SHEET TITLE: PROJECT LOCATION, INDEX
PROJECT: MODIFICATIONS OF THE OFFICES OF COMPREHENSIVE PLANNING

PROJECT: MODIFICATIONS TO THE OFFICES OF COMPREHENSIVE PLANNING

PROJECT: MODIFICATIONS OF THE OFFICES OF COMPREHENSIVE PLANNING

SHEET NO. A-1

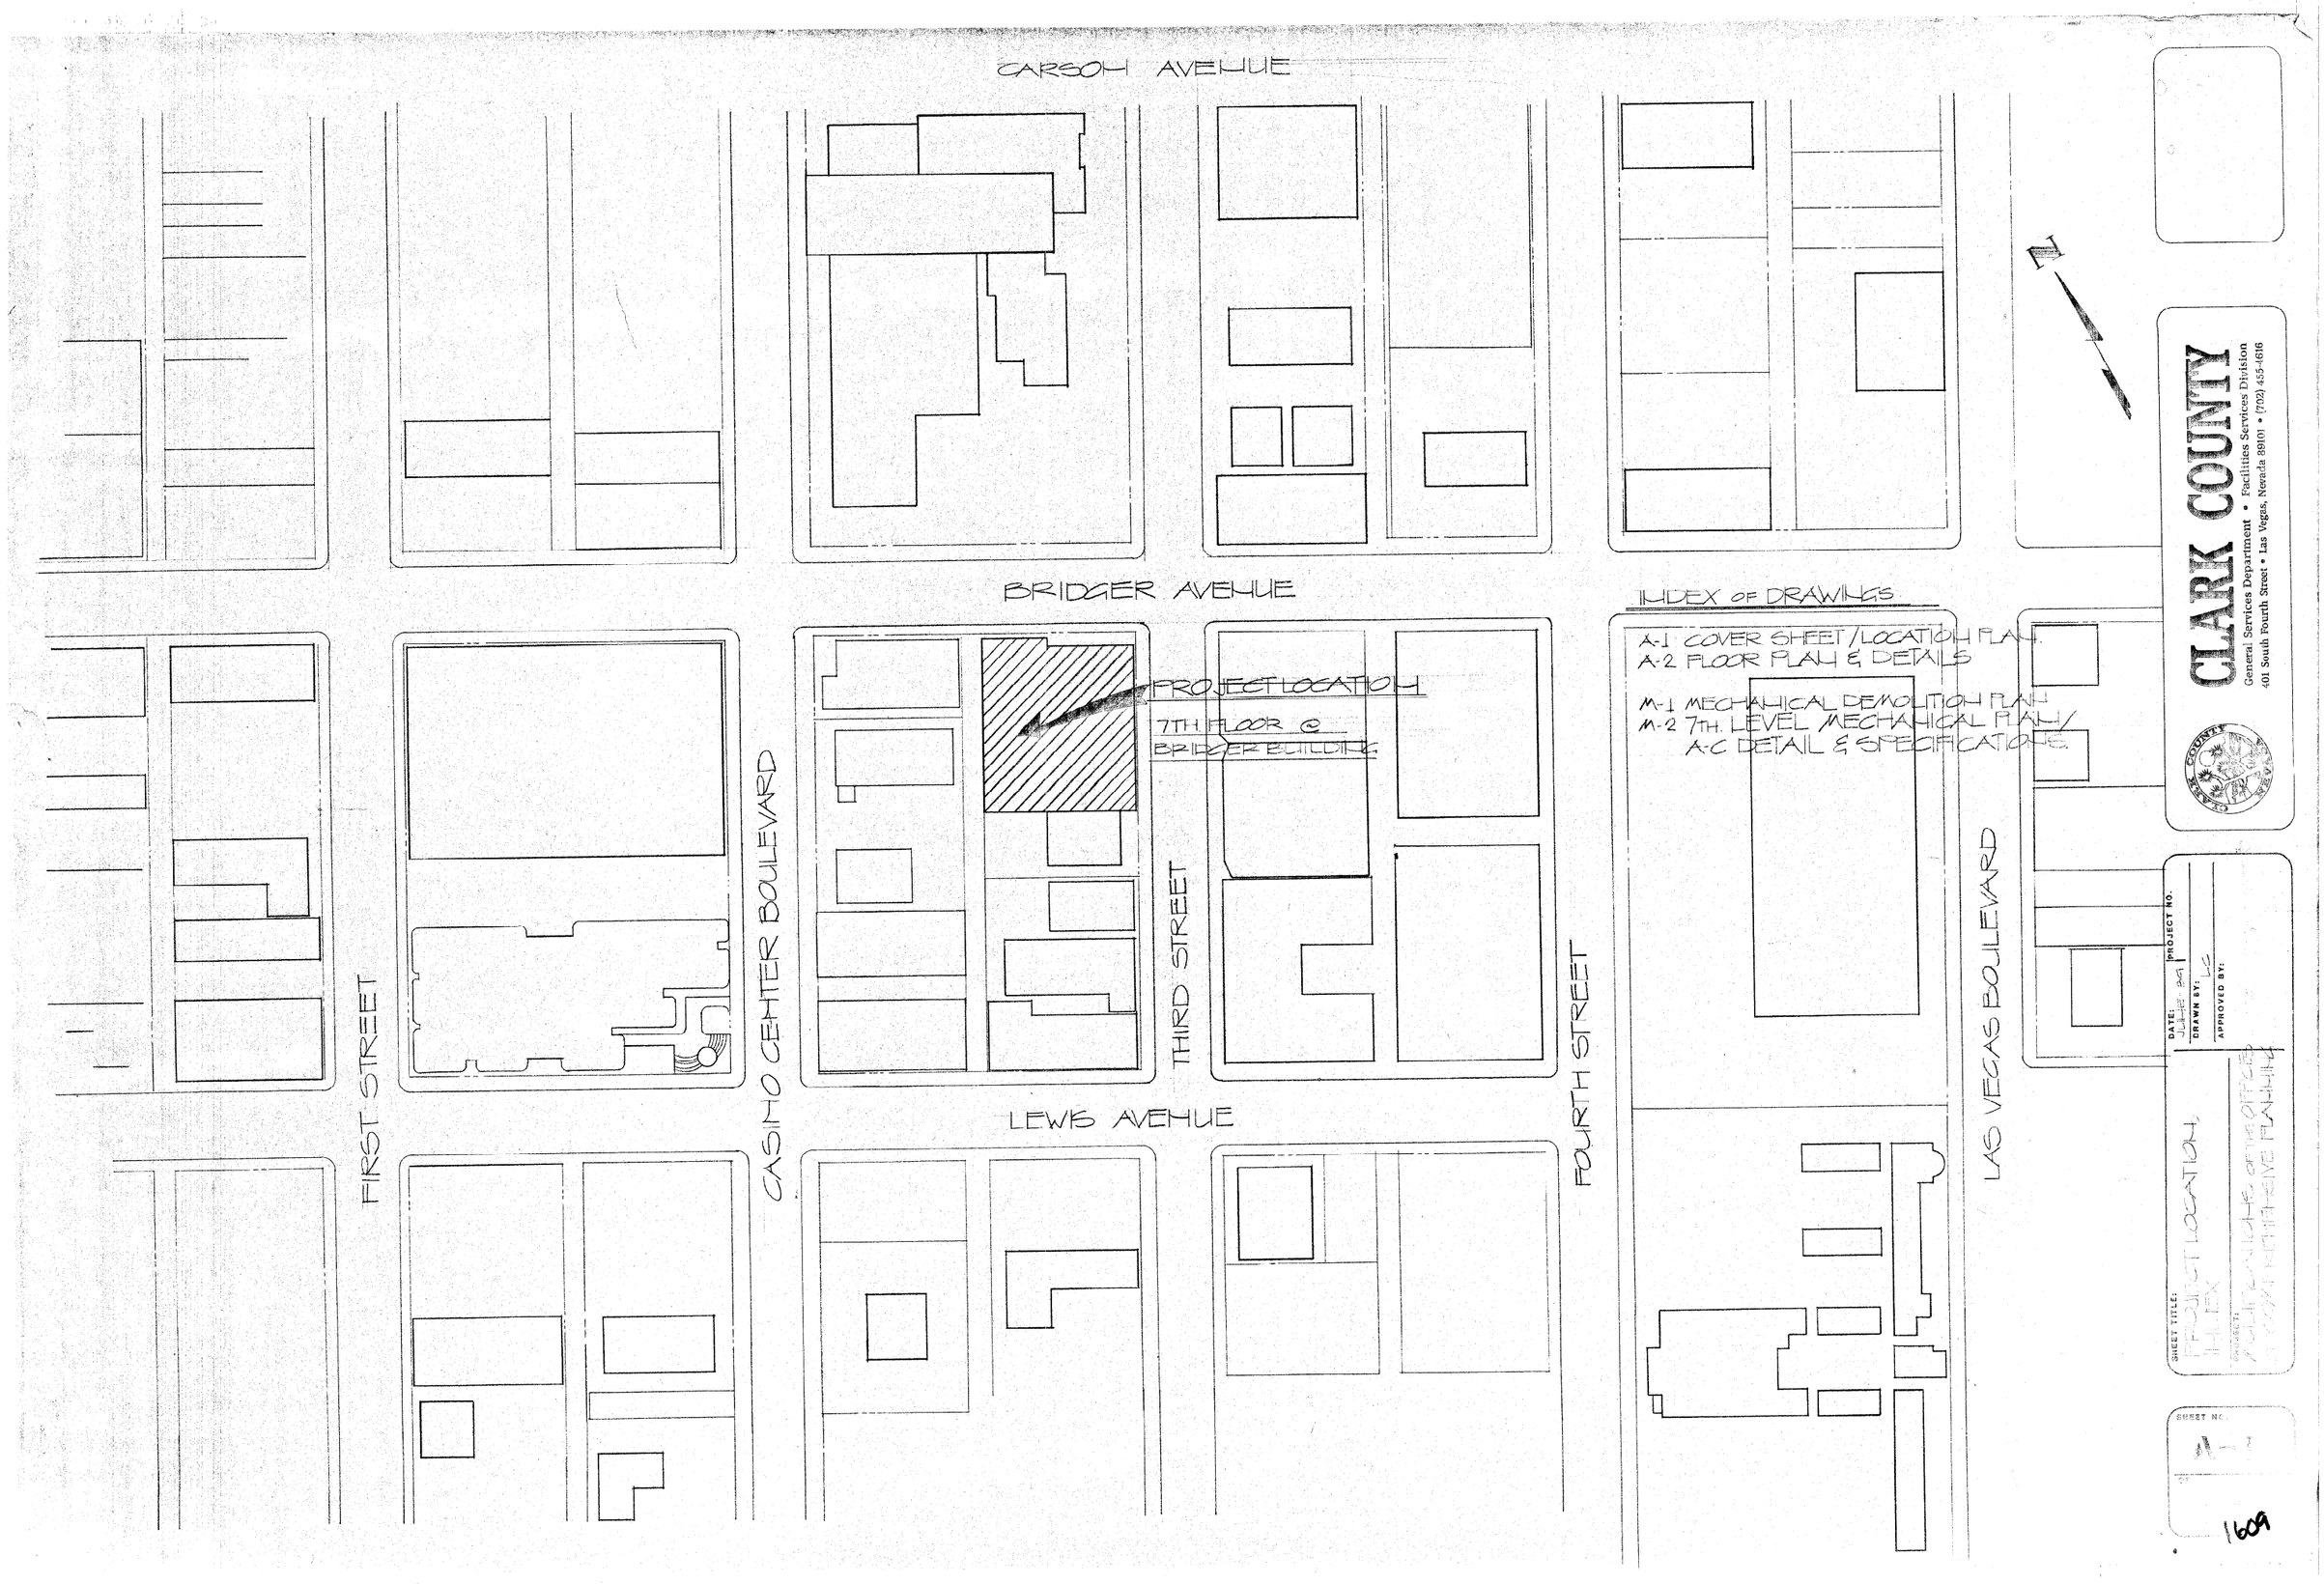
New 30 Kw Power Conditioner: 10 KVA
Existing Load relocated 8 KVA
New Computer loads
18 KVA total

7TH. LEVEL MECHANICAL PLAN

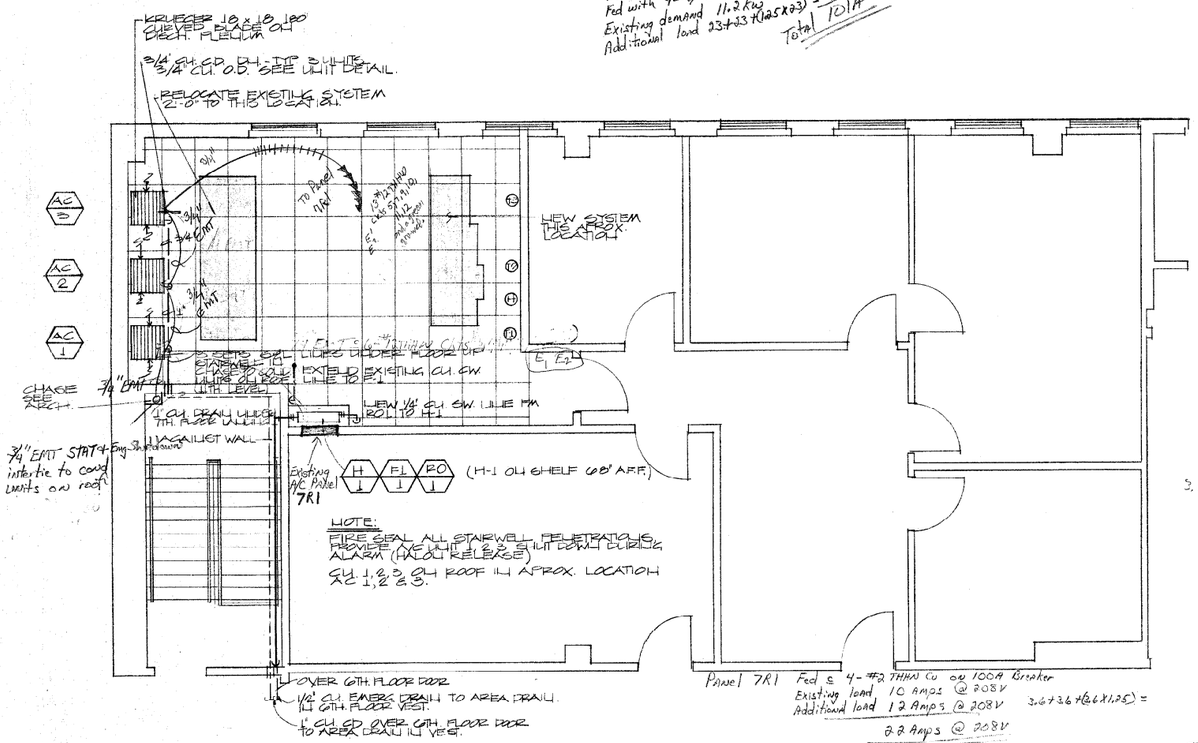
Cond's on roof: 1" EMT TO PANEL PR (Penthouse) 3ea 2P 40A CKTS (20,22-24,26-23,25)

NOTES Panel "PR" (Existing 30ckt Panelboard located in Penthouse)
200A 120/208V 3ø 4w
Fed with 4-#3/0Cu
Existing demand 11.2 kw = 31A
Additional load 23+23+3(.25x23) = 75A
Total 101A

E_1 Emergency Computer Shutdown (Connect Shunt trip Breaker in conditioner to E_1)

E_2 Emergency A/C Shutdown

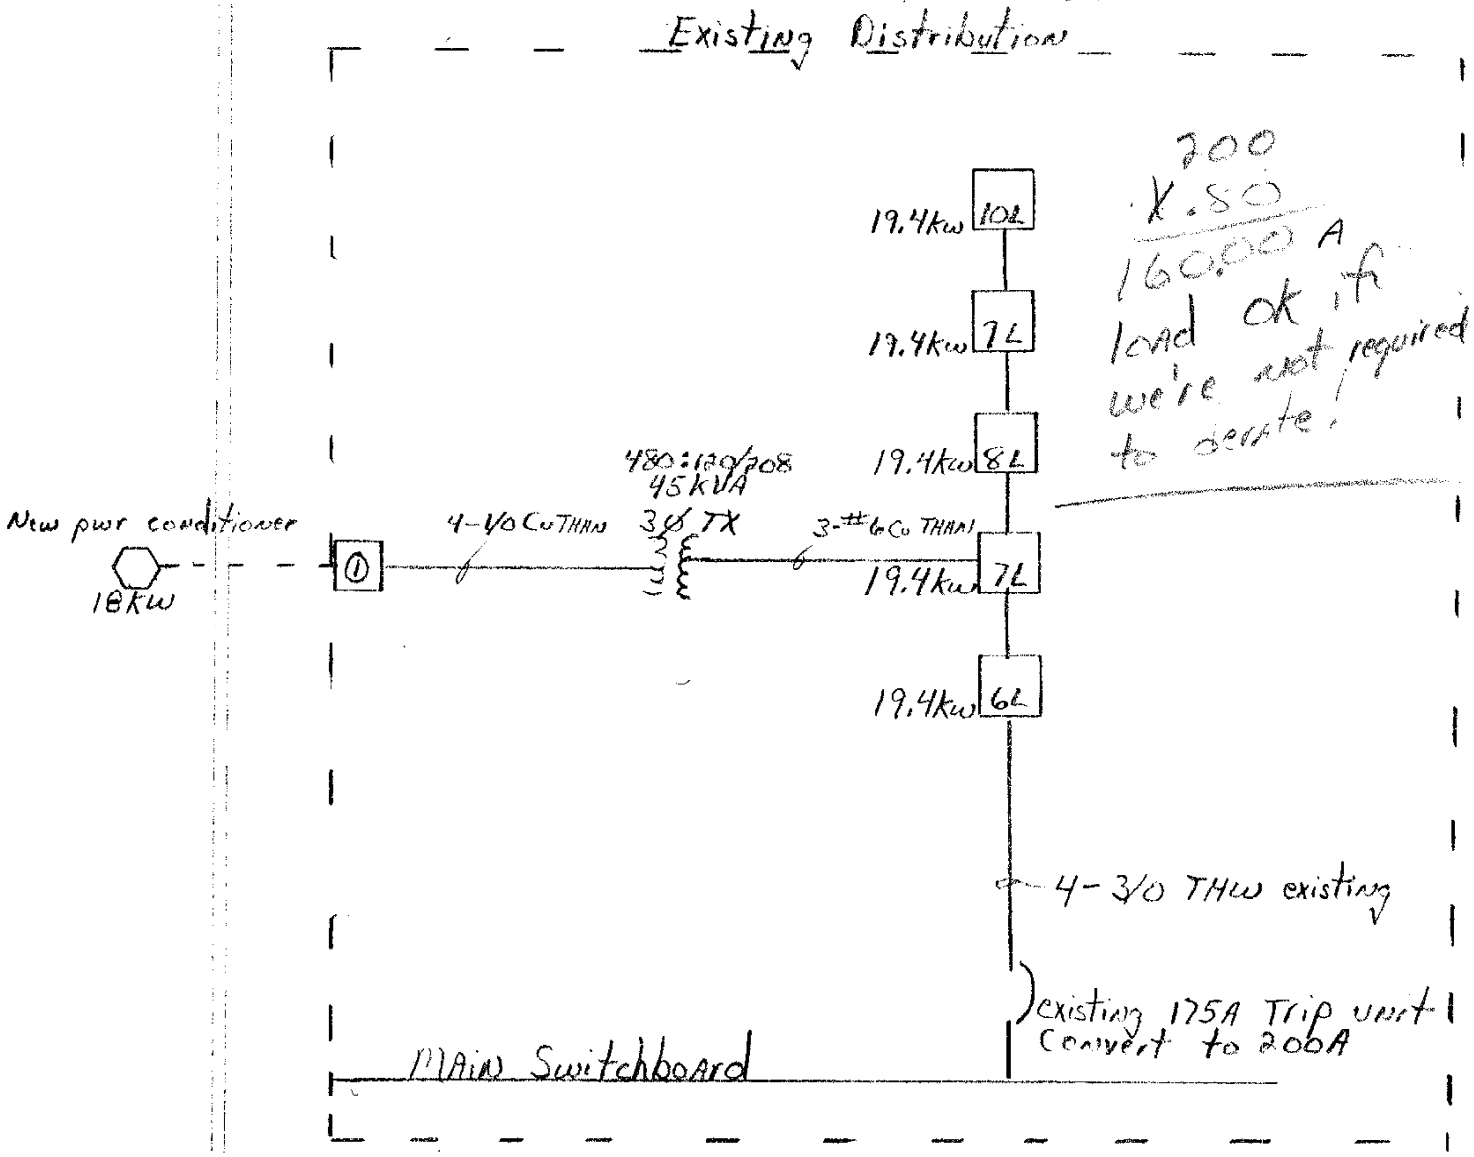
Existing demand 19.4kw X ~~X~~ 5 = 97kw Exist. Connected load

Additional load 18kw = 18kw

115 kw ÷ 480 X 1.73 = 139A NEW load

200
X .80
160.00 A
load ok if we're not required to derate.

① Convert existing 100A 3Ø 4w 120/208V panel to J/BX & extend 4ea 1/0 Cu cond to feed new 30kw power Conditioner

⬡ New power conditioner for new computers 18 kw load

New Computer loads 8-29-89
